**Subject: WALLERAWANG BATTERY ENERGY SYSTEM – SHELL ENERGY Approval Modification –  
Amendment Report (SSD-14540514-Mod 1)**

Date: 23 September 2025

*Summary of agency responses received*

Figure 1: Comparison of the EIS/Modification site boundary (red dotted line) and Amendment Report site boundary in relation to the mapped vegetation zones

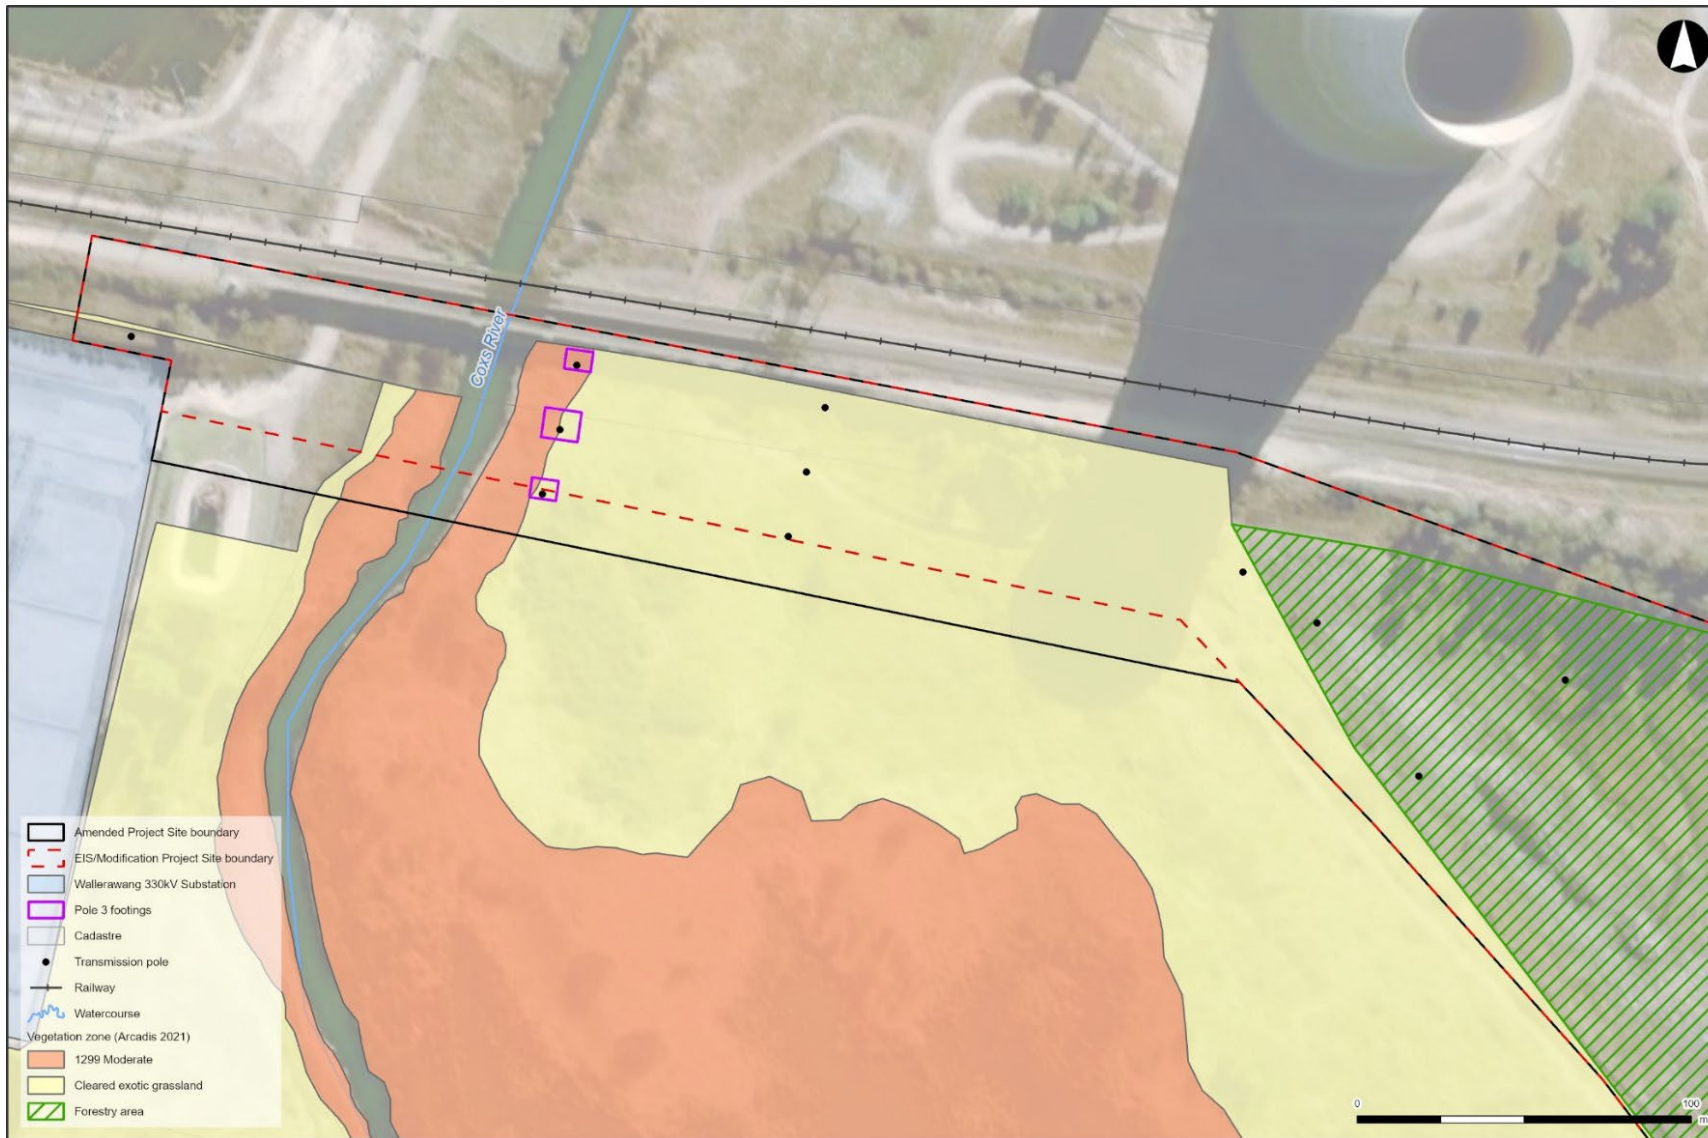
2	<p>The modified layout depicted in Figure 3.2 of the Amendment Report appears to intersect with vegetation consistent with Plant Community Type (PCT) 1299, as mapped in Figure 3-4 of the BDAR. CPHR is seeking clarification on whether there will be an increase in impact to native vegetation in the areas mapped in Figure 3.2 and described in Table 3.1.</p> <p>If the project increases impacts to biodiversity values, a BDAR may be required in accordance with section 7.17 of the <i>Biodiversity Conservation Act 2016</i>.</p>	<p>The locations of the transmission line structures remains unchanged from the locations proposed in the Modification Report. However, to allow for some flexibility and to accommodate disturbance during construction of the transmission line structures, the transmission line corridor was shifted south by 15 metres. This area has been previously assessed in the original Biodiversity Development Assessment Report (Arcadis, 2021).</p> <p>Figure 1 below compares the extent of vegetation zones for the EIS / Modification Report (red dotted line) and the Amendment Report (solid black line). As shown, the location of the transmission line structures remains unchanged from that shown in the Modification Report and the area of disturbance assessed in the Addendum BDAR, also remains unchanged.</p> <p><b>Impacts to PCT 1299, are consistent with what was assessed in the Addendum BDAR and as such, a subsequent BDAR is not required.</b></p>	<p>Addendum BDAR (Arcadis, 2025)</p> <p>Modification Report (Arcadis, 2025)</p>
